PLAN COMMISSION AGENDA ITEM EXECUTIVE SUMMARY			
	Project Title/Address:	The Quad St. Charles – Starbucks		
	City Staff:	Russell Colby, Planning Division Manager		
	PUBLIC HEARING		MEETING 5/3/16	X
APPLICATION:		PUD Preliminary Plan		
ATTACHMENTS AND SUPPORTING DOCUMENTS:				
Staff Report		PUD Preliminary Plan Application		
PUD Preliminary Plan				
SUMMARY:				
<p>The subject property is Lot 4 of The Quad St. Charles, Unit 2, located at the northeast corner of Main St./Rt. 64 and the 38th Ave. entrance into the Charlestowne Mall site. The property is one of five outlot parcels created last year along the mall's Main St. frontage.</p> <p>SC Outparcel One, LLC (Krausz Companies) is proposing to develop the lot with a two-unit building. Starbucks will occupy the southern unit. Approval of a PUD Preliminary Plan is required to ensure compliance with the PUD ordinance and applicable provisions of the Zoning Ordinance.</p> <p>The proposal includes the following:</p> <ul style="list-style-type: none"> • 4,472 square foot building with a drive-through facility • 31 space parking lot • Access provided via the mall ring road on the north side of the lot

RE: The Quad St. Charles, Unit 2, Lot

Landscape Plan

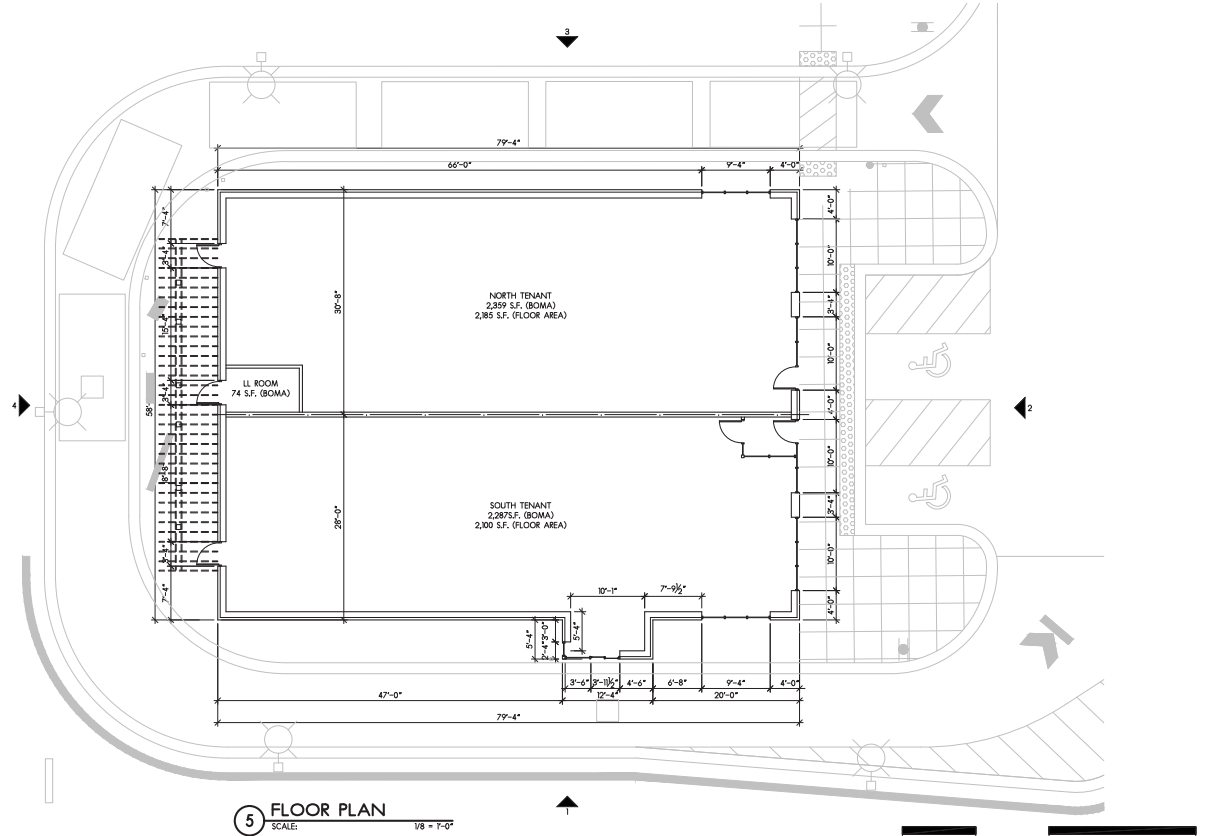
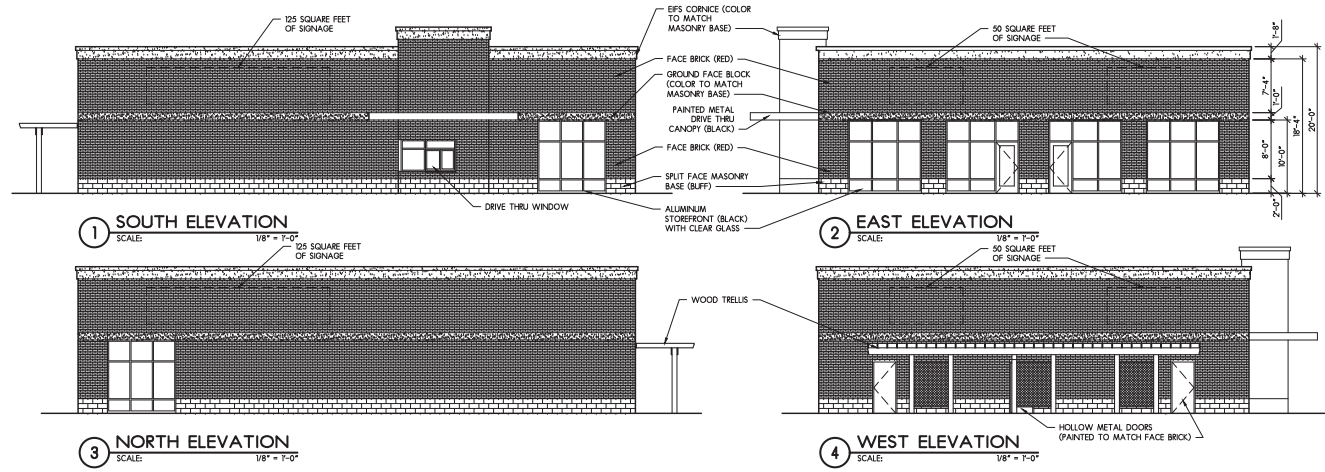
- Additional trees should be added on the north and west side opposite the drive-through aisle. There is also adequate space for additional planting beds.
- There are five ornamental trees along Main St. Some of these should be replaced with shade trees.

DATE: 04-05-2016
PROJECT NUMBER
25196
SHEET NUMBER
A1.1

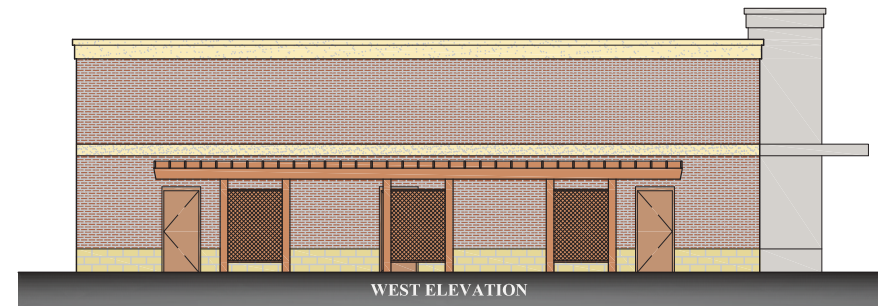
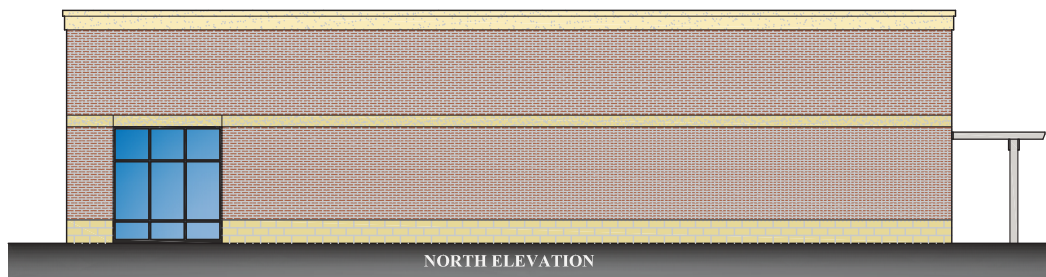
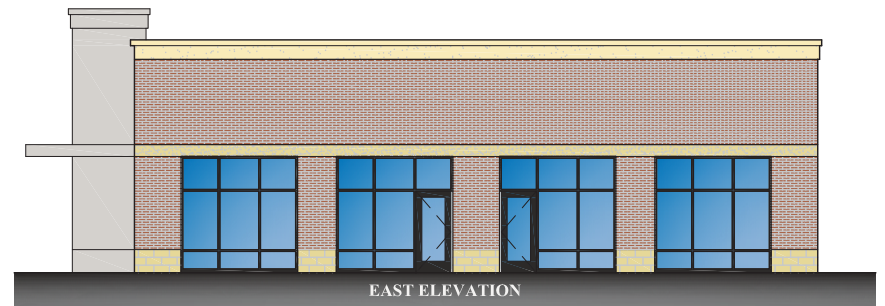
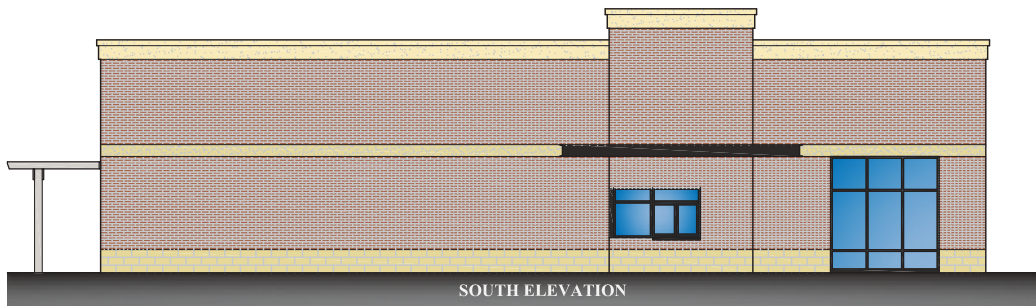
- Additional architectural features must be added on the south and west facades.
 - o The applicant has provided a list of the features and square footages counted towards meeting this requirement. However, the signage area exceeds the sign size limitations. Also, it is unclear how the area of the tower was calculated.
 - o Staff suggests widening the block band and masonry base around the building.
- Awnings or canopies must be added over the building entrances to provide required articulation.
